City of Santa Fe, New Mexico

memo

2025-011459-HDRB, 912 Don Gaspar Ave, Don Gaspar Area Historic District, significant, Positive Energy Solar, agent for Moe Zamora, owner, proposes to install publicly visible solar. Exceptions are requested to section 14-5.2(D)(3)(b) for publicly visible rooftop appurtenances and 14-5.2(D)(5)(b) for placing features on a primary facade.

Figure 4: Site Plan location of panels

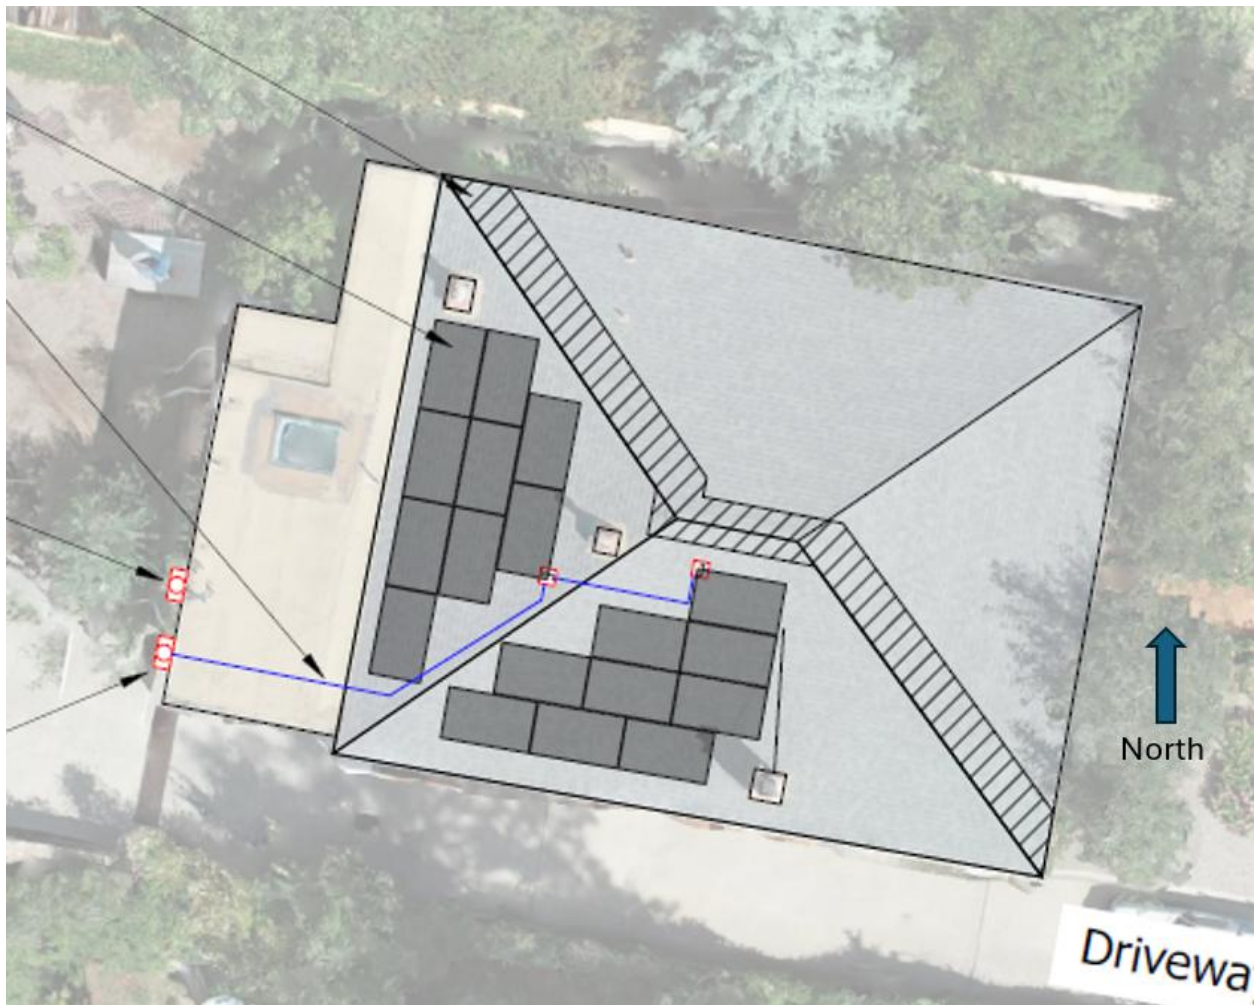
1. Install publicly visible solar on a primary façade. The panels will be flat against the pitch of the roof. Nine panels will be installed on the west elevation roof, and nine panels will be installed on the south elevation roof. The west elevation is the rear of the house and will be publicly visible from West Houghton Street. The south elevation is publicly visible from Don Gaspar Avenue. Don Gaspar Avenue is one-way going south, so the vehicle traffic will not immediately see the panels; however, pedestrians will be able to see the array. The proposed solar panels on the south elevation have been setback from the front of the building to mitigate the impact on the streetscape. Exceptions are requested to section 14-5.2(D)(3)(b) for publicly visible rooftop appurtenances and section 14-5.2(D)(5)(b) for placing features on a primary façade.

Staff Response: Staff finds that this criterion is not met. While vehicle traffic may not see the panels due to the direction of the one-way street, pedestrians are able to circulate both north and south and will be able to see the panels on the south elevation from Don Gaspar Avenue. They will be able to travel east and west on West Houghton Street, where the west elevation panels will be publicly visible. Foliage is not considered screening as it can be removed, though staff recognizes that the west elevation array will not be publicly visible. While the solar panels are integrated into the pitch as required by section 14-5.2(H)(1)(c)(iv) for the Don Gaspar Historic District, this particular property is a significant structure, and publicly visible solar is not allowed because it will detract from the significant building and the district.

Staff Response: Staff finds that this criterion is met. Other design options have been considered and do not provide for the needs of the homeowner. The west elevation panels are not publicly visible and could be considered, but the south elevations are publicly visible and as minimally visible as possible with a pitched roof. Solar panels are encouraged in the Don Gaspar Area Historic District, and these solar panels are integrated into the pitch as required by section 14-5.2(H)(1)(c)(iv) for the Don Gaspar Historic District.

Staff Response: Staff finds that this criterion is not met. This addresses public visibility, but does not place the solar on a primary facade. While the solar panels are integrated into the pitch as required by section 14-5.2(H)(1)(c)(iv) for the Don Gaspar Historic District, this particular

Staff Response: Staff finds that this criterion is not met. The applicant has not shown that there is a hardship sufficient for solar panels on the primary façade of a significant structure.

Staff Response: Staff finds that this criterion is not met. The applicant has offered a range of options for other locations, including the possibility of a pole-mounted or ground-mounted option. However, it does not address the fact that the roofs of the residence are primary facades of a significant structure.

Staff finds that the exception criteria to section 14-5.2(D)(3)(b) have not been met and recommends denial for publicly visible rooftop appurtenances, and the exception criteria to section 14-5.2(D)(5)(b) have not been met and recommends denial for placing features on a primary facade. Staff recommends denial of the application as it does not comply with 14-5.2(D) General Design Standards for all Historic Districts, and 14-5.2(H) Don Gaspar Area Historic District Design Standards.
